MAY 18, 2026 REGULAR MEETING

Coastal Development Permit No. 23-073 / 32832 Pacific Coast Highway

A. Coastal Development Permit No. 23-073, Variance No. 25-019, Site Plan Review No. 23-035, and Minor Modification No. 24-005 – An application for the construction of a single-family residence and associated development (Continued from March 16, 2026)

Following the Commission meeting, on April 8, 2026, the applicant submitted revised project plans addressing both requests (Exhibit B). The revised plans include additional dimensions, clarifications, and an updated TDSF General Notes sheet (Sheet A-041) confirming that there are no covered exterior areas six feet or greater in depth; therefore, no square footage has been allotted toward the maximum allowed TDSF differently than what had been represented at the past meeting. The applicant also submitted a View Corridor Memorandum (Exhibit C) documenting the basis for the view corridor location, driveway tree, and frontage vegetation.

CITY OF MALIBU
ENVIRONMENTAL SUSTAINABILITY DEPT.
ENVIRONMENTAL HEALTH

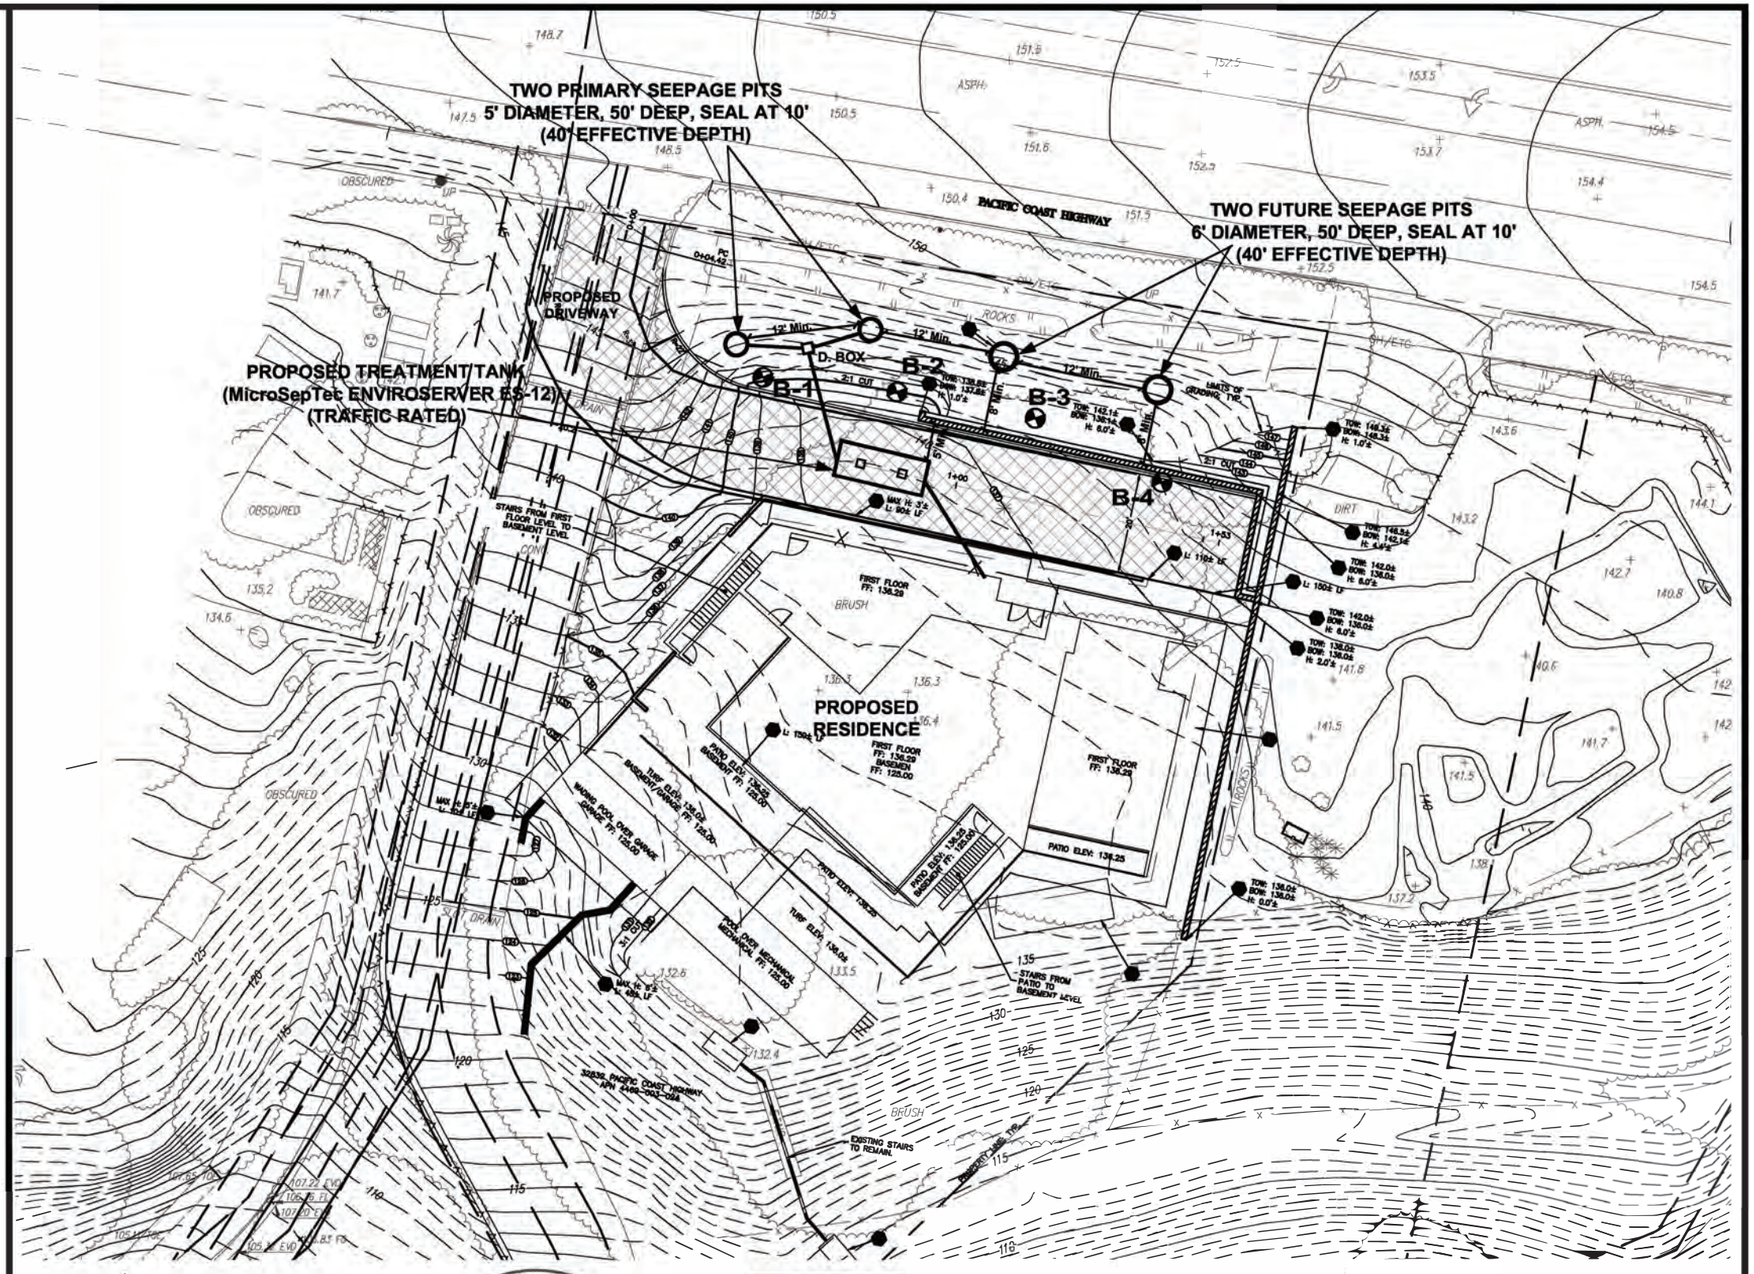
- Sheet A1.01 of the architectural plans depicts an outdoor sink. Per the 2016 California Plumbing Code, stormwater shall not be drained into sewers intended for sanitary drainage (1101.3). All outdoor fixtures must be covered by a permanent cover to decrease uncontrolled flow into the OWTS. Revise the plans, accordingly, and submit for review.
